REQUEST Current Zoning: R-3 (single family residential)
Proposed Zoning: R-12MF(CD) (multi-family residential, conditional)

LOCATION Approximately 7.05 acres located on the east side of South Tryon Street, north of Shopton Road West.
(Council District 3 - Mayfield)

SUMMARY OF PETITION The petition proposes to allow up to 72 multi-family residential units on vacant land located to the south of the Rivergate Mixed Use Activity Center.

PLANNING STAFF REVIEW

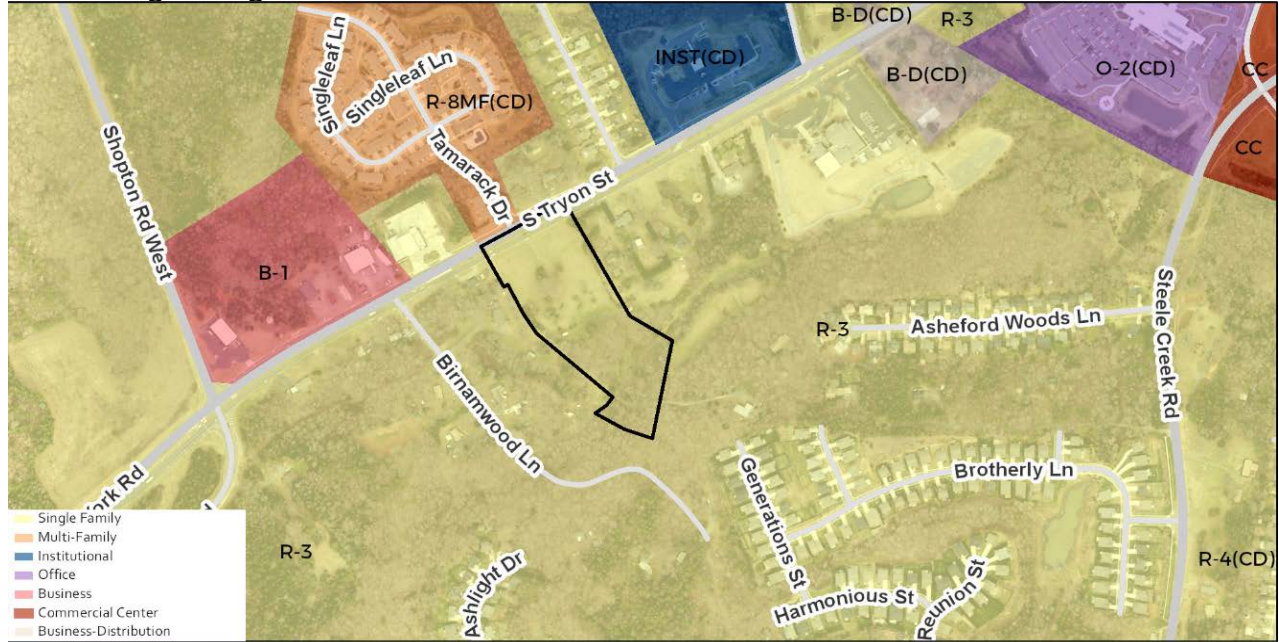
1. Reduce unit count to comply with Steele Creek Area Plan density recommendation of eight dwellings per acre. **Not addressed.**
2. Provide a buffer/fence for the single family residential property located to the southwest of the subject site. **Not addressed.**

3. ~~The petitioner should revise the site plan to show Public Street A 71' right-of-way extending to the southern property line and construction a future connection to existing Generation Street.~~ **Addressed.**
4. ~~The petitioner should revise the site plan to show Public Street B with parallel parking. If angled parking is desired, must be reverse angle with 14' wide travel lane adjacent to the angle parking and 10' wide travel lane adjacent to the parallel parking (total 24' travel width). Reverse parking stall depth is 18' (measured perpendicular to the curb), stall width is 10.5' (measured parallel to travel lane).~~ **Addressed.**

5. ~~Site is in a wedge and will be required to provide 15% tree save area based on gross acreage. 15% of 7.05 acres = 1.05 acres tree save. Show tree save and calculations area on site plan. Tree save must contain existing healthy tree canopy. Tree save must be 30 feet width minimum.~~ **Addressed.**
